CALIFORNIA COASTAL COMMISSION

F13a

To: Commissioners and Interested Persons
From: Dan Carl, Central Coast District Director
Mike Watson, Central Coast District Coastal Planner
Subject: **STAFF REPORT ADDENDUM for F13a**
Application A-3-SNC-98-114-EDD (SNG Dispute Resolution Hearing)

Cross Section Y2

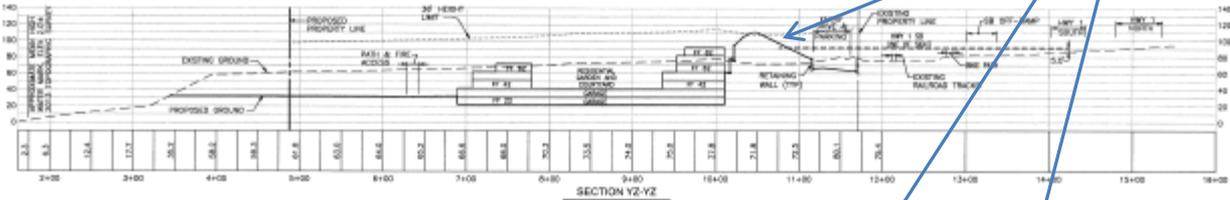
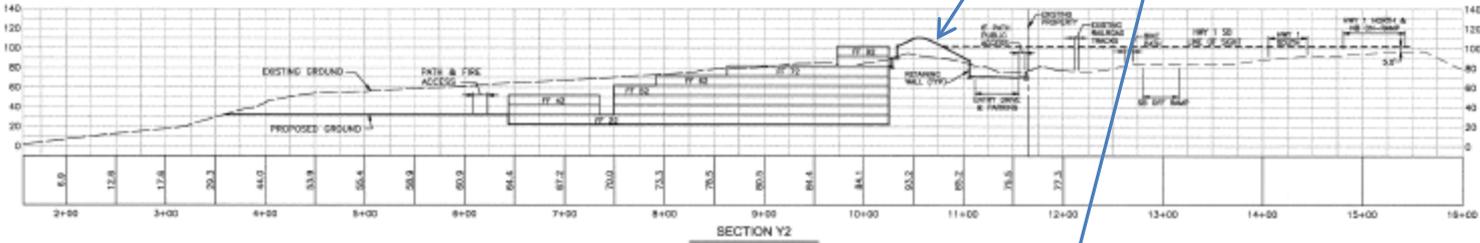
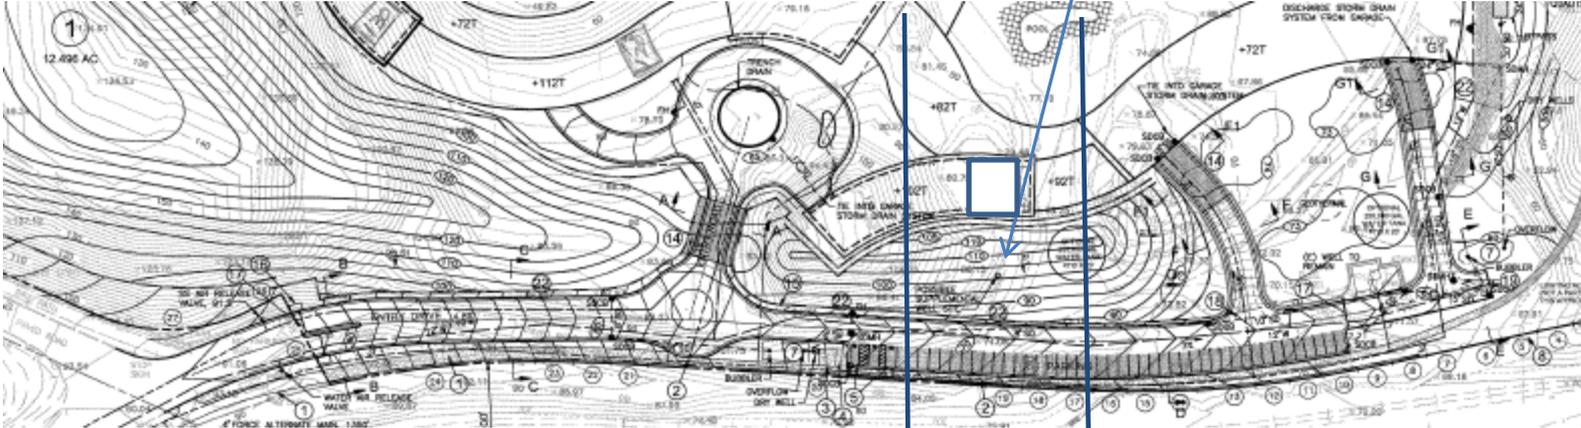
Dune configuration and height not sustainable.

SIGNAGE PLAN
Conceptual Sign Locations

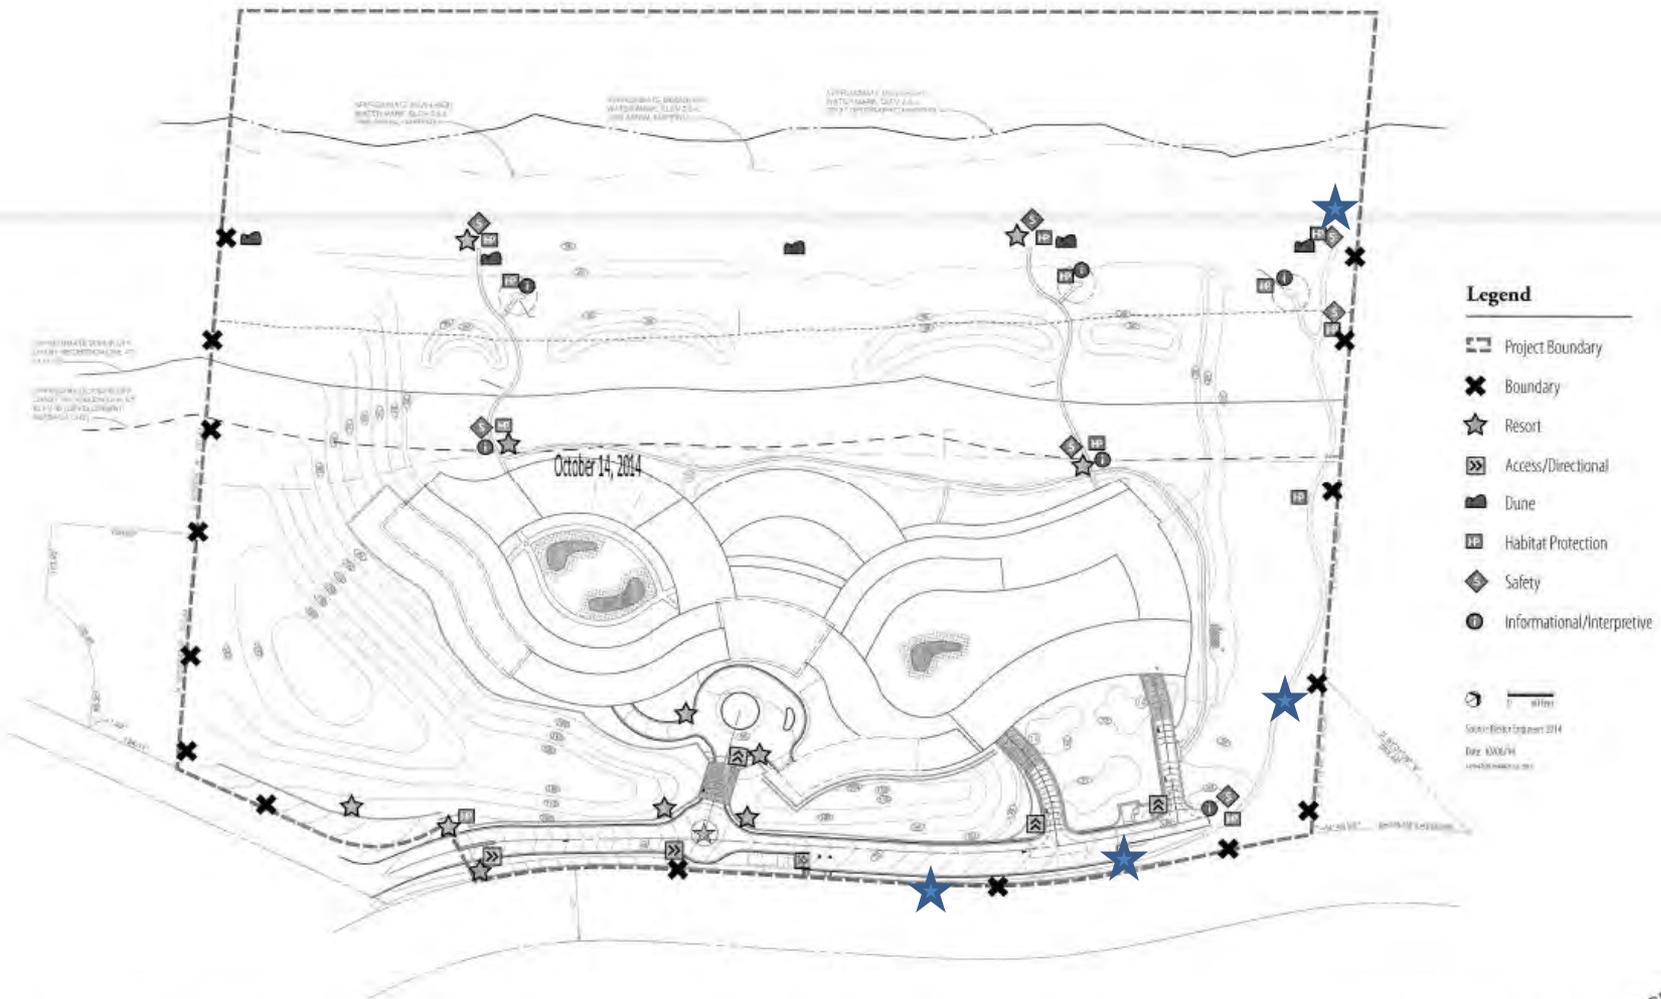
Lastly, staff has repeatedly requested that additional way-finding signs be installed along the public parking lot and out towards the public pathway and to the beach and beach access stairway. The current iteration of the Public Access Management Plan does not show any such directional signage in this location. Refer to Exhibit 11 for the location of the required additional directional signs.

★ Additional access way-finding signs needed.
